TRI-COUNTY TECHNICAL ADVISORY COMMITTEE

STAFF REPORT

SUBJECT: Variance Application for 342 East Meadows Drive, Kirkwood, File # 2025-219.

Attachment 1
East Meadows Building Envelopes

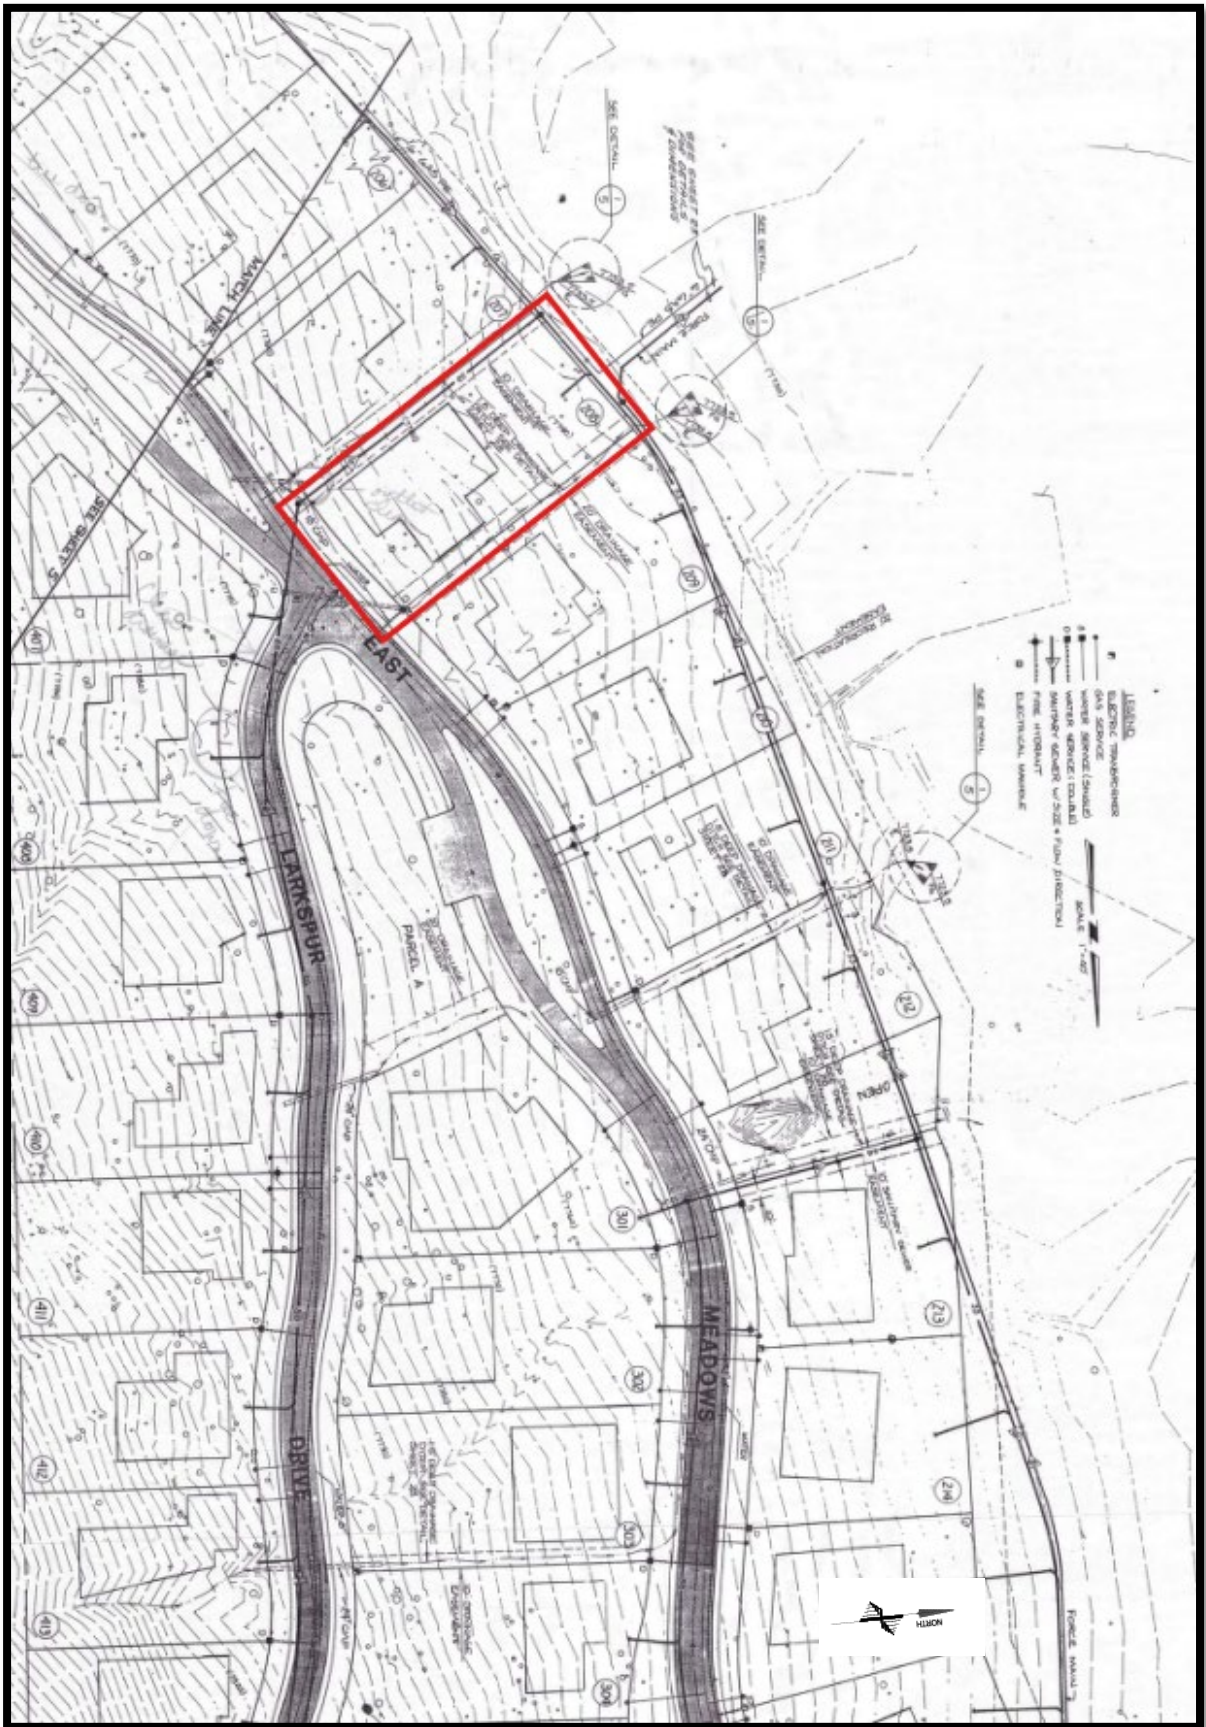
- A. Allow a major modification of the building envelope for lot 208 of the East Meadows subdivision. The existing building envelope is 5,296 sq ft, the variance would remove 1,305 sq ft from the southern portion of the building envelope and add 1,305 sq ft to the northern portion of the building envelope. Keeping the building envelope at 5,296 sq ft.
- B. And to allow for a driveway with a 24 ft width – exceeding the Kirkwood Specific Plan requirement of 14 ft maximum width. These modifications are proposed for a new single-family residence and driveway access.

When the property was purchased, there was no record of the underground electric utility line in the purchase report. KMPUD also had no record of it and had to wait until the snow melted to determine if the line existed and the location on the property. Once a survey was done it was discovered that the line was within the boundary of the approved building envelope.

The moving of the building envelope will not place the structure in a location with greater site constraints, the site has similar slope along the entire property, with the steepest section being along the front of the lot (see attachment 4).

It is the opinion of the staff that the underground electric utility easement prevents the property owner from using the property as intended in the original East Meadows Subdivision Map and granting this variance is necessary to construct a reasonable single-family residence justifying the granting of this building envelope modification.

1. Approval of the zoning variance without conditions for:
 - a. A major building envelope modification
 - b. A driveway width variance to 24 feet

Site Plan

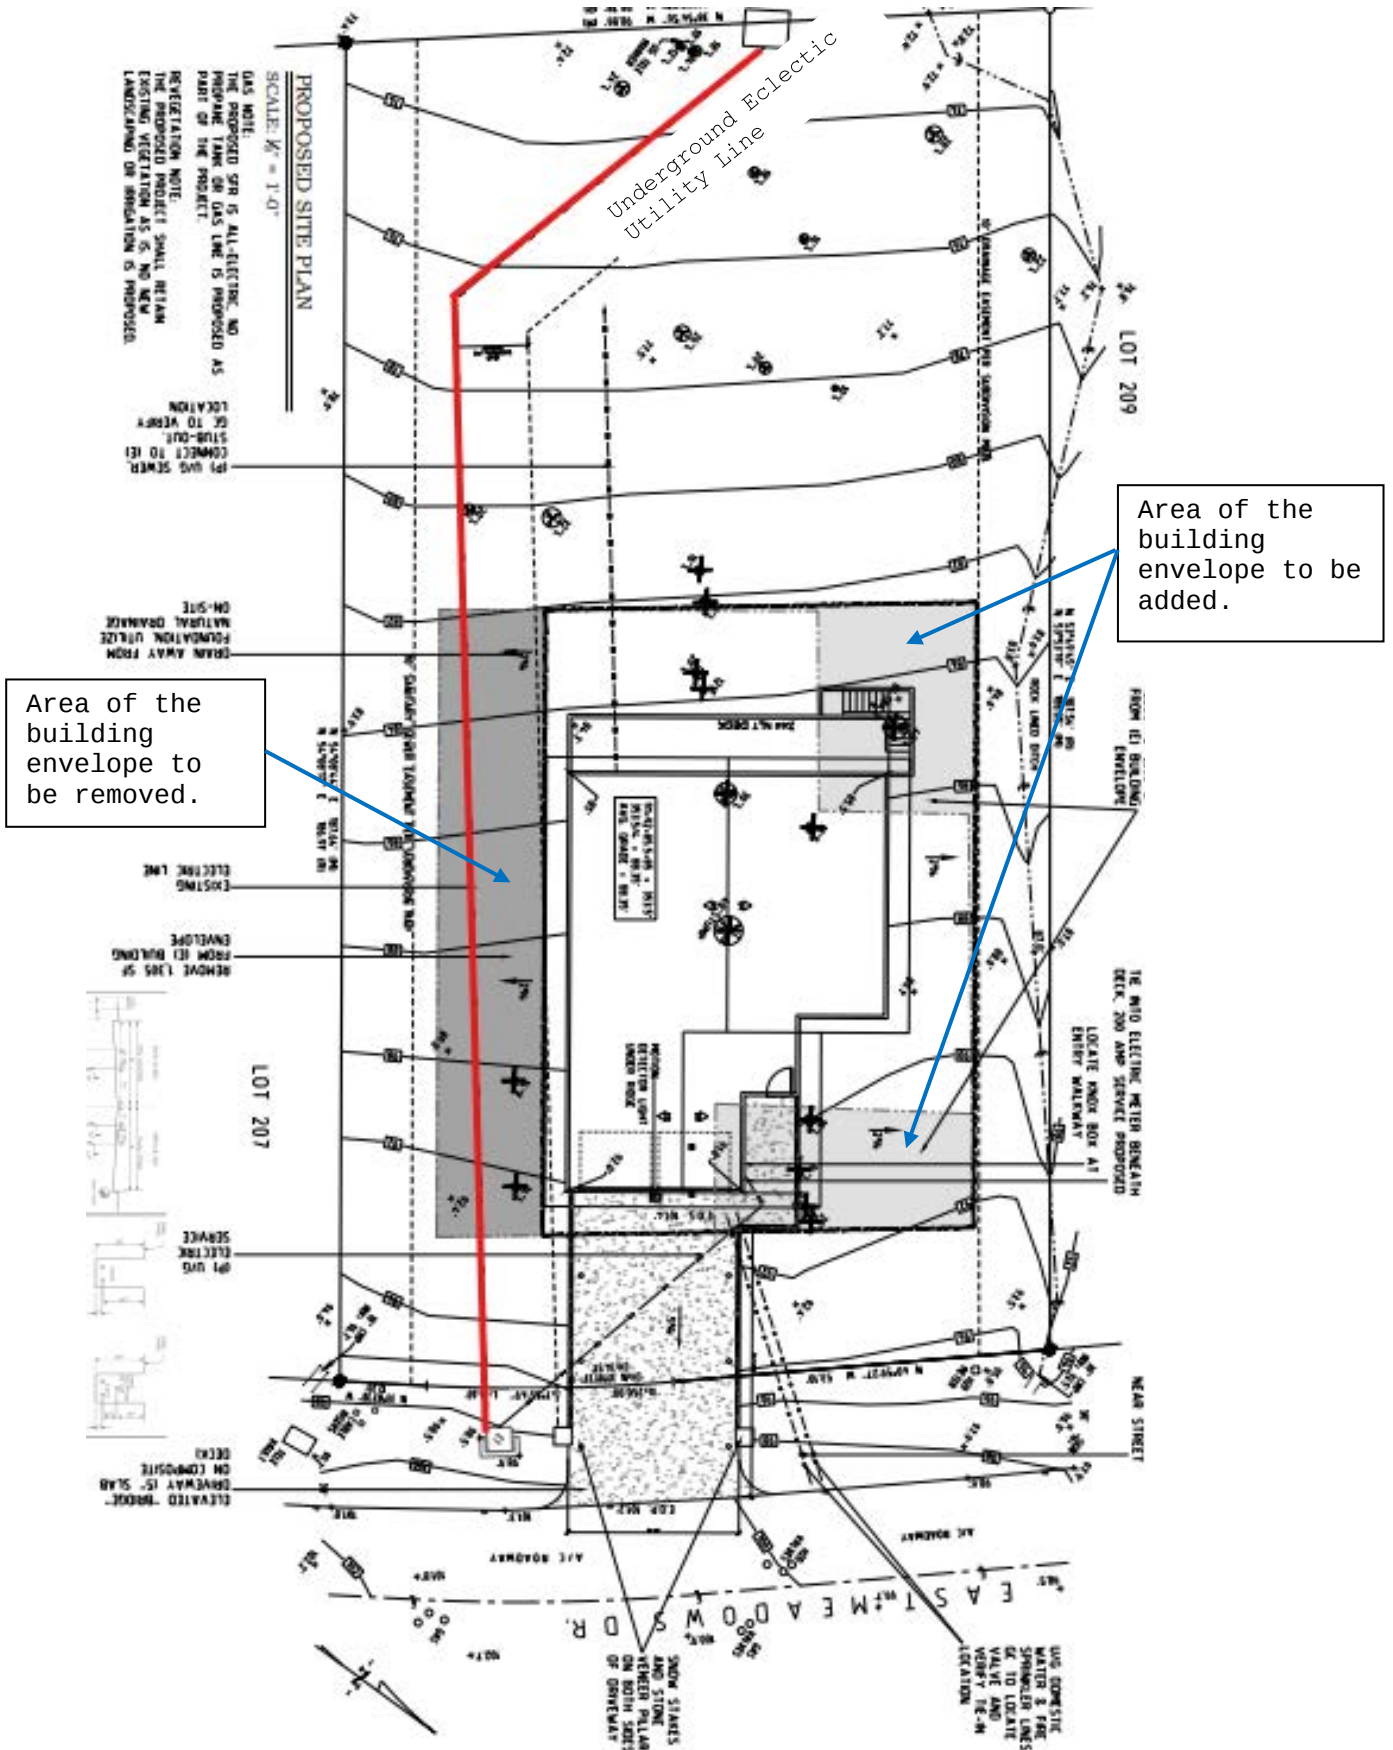
In addition, the applicant is requesting a driveway width of 24 ft, an increase from the 12-14 ft required by the Kirkwood Specific Plan Appendix 4 Design Ordinance, Driveway and Site Access Section C.1.a.

The Kirkwood Specific Plan requires driveways be between 12-14 ft to provide enough space between driveways for snow removal. The East Meadows Design Guidelines allow for driveways up to 24 ft in width. Because the East Meadows HOA is responsible for snow removal in this area of Kirkwood, staff would defer to the HOA on the driveway width. Additionally Alpine County Design Standards Table 9-1 allows a driveway width of 28 feet on other areas of the County outside of Kirkwood.

KMPUD and EMACC have reviewed and approved plans (see attachment5)
